**Re: Justification for CEQA Appeal of Case Nos. DIR-2023-4996-TOC-HCA;
ENV-2023-4997-CE; 1459 S. Hi Point Street**

Q Condition Conformance Review

Subject: 1459 Hi Point St.; DIR #2023-4996-TOC-HCA including -1A

Inconsistency in plans Approved in Director Determination. Sheet A4 of Drexel Construction

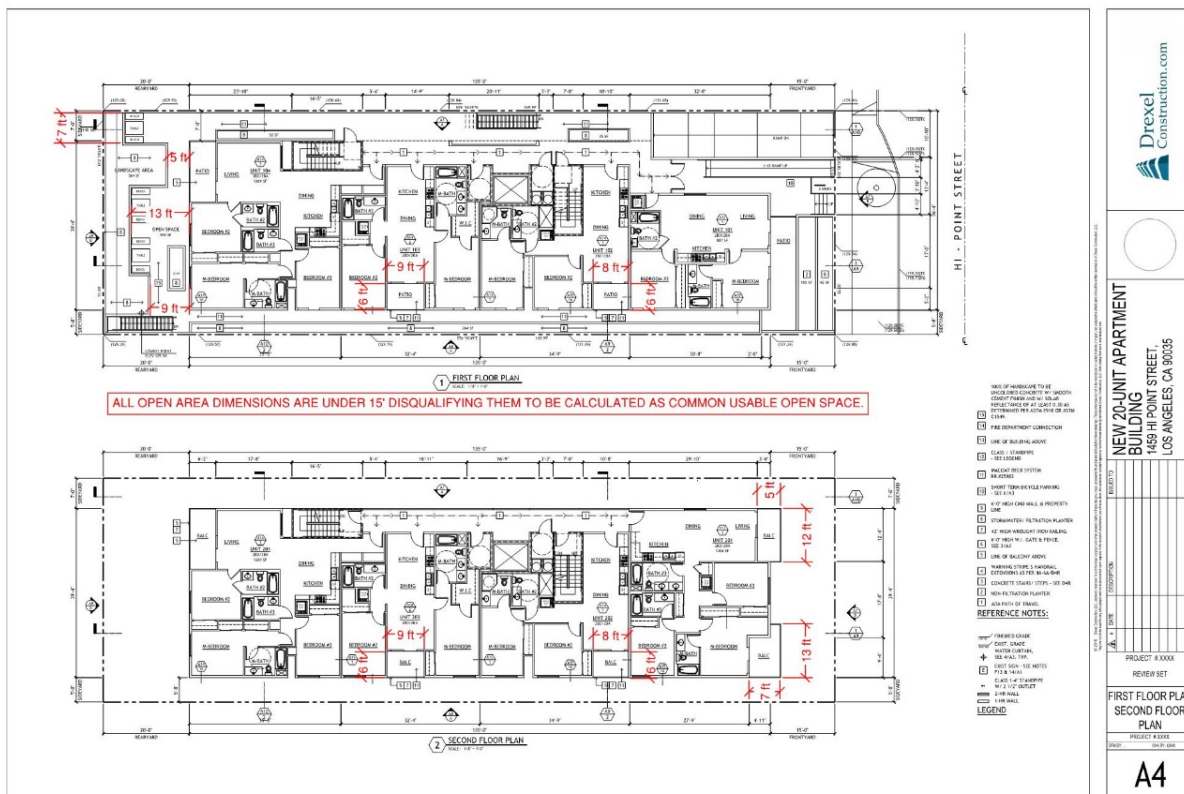
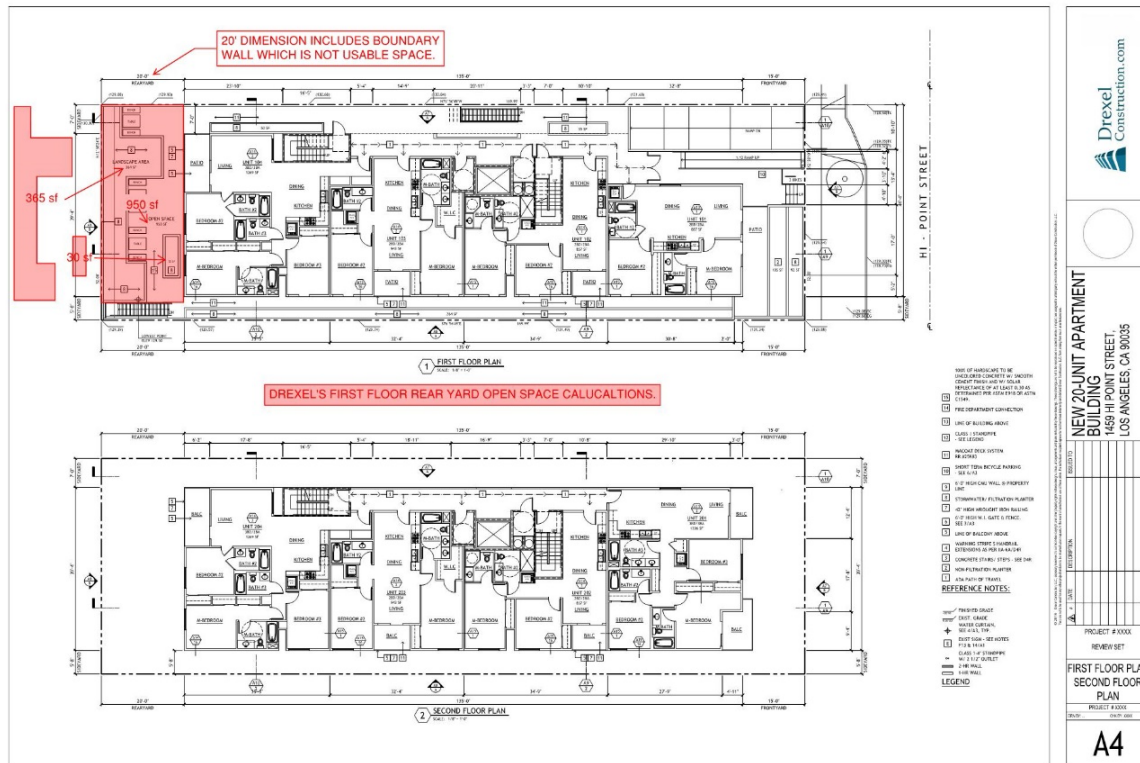
- a. The Architectural and Landscape plans each present “open space” calculations which do not match the other; the “Approved” plans don’t match each other, and do not match the “Approval” text. This is noteworthy, and affects the rear yard and 4th floor rooftop.

Finding: Neither set of Approved Plans provides a “usable open space” calculation. Each plan set does have its own “open space” calculation, without showing its source Code derivation. This failure to provide the correct calculations leads to totals that are not approvable. The inclusion of 592 sf of “rooftop” is not permitted in the Q Conditions. See **Attachment B** and **C**

- while the “average width” of 20’ is dimensioned in the rear yard area on the plans, the “floor area” or “area” is less. The thickness of the outer walls reduced the dimension below 20’. Further, building sections show that this area is broken up by 4’ high planter walls, making it non-continuous and not “usable”. To make the areas atop the 4’ planter walls usable, they would need to be accessible to people via stairs, and safe for those people with guardrails-- as the height exceeds 30” drop.
- The minimum width of the usable are at 15’ is not achieved in either the rear yard or the rooftop—if any argument is made to include the rooftop.

5th floor open space not shown;
architectural drawings omit aspects required for landscape approval
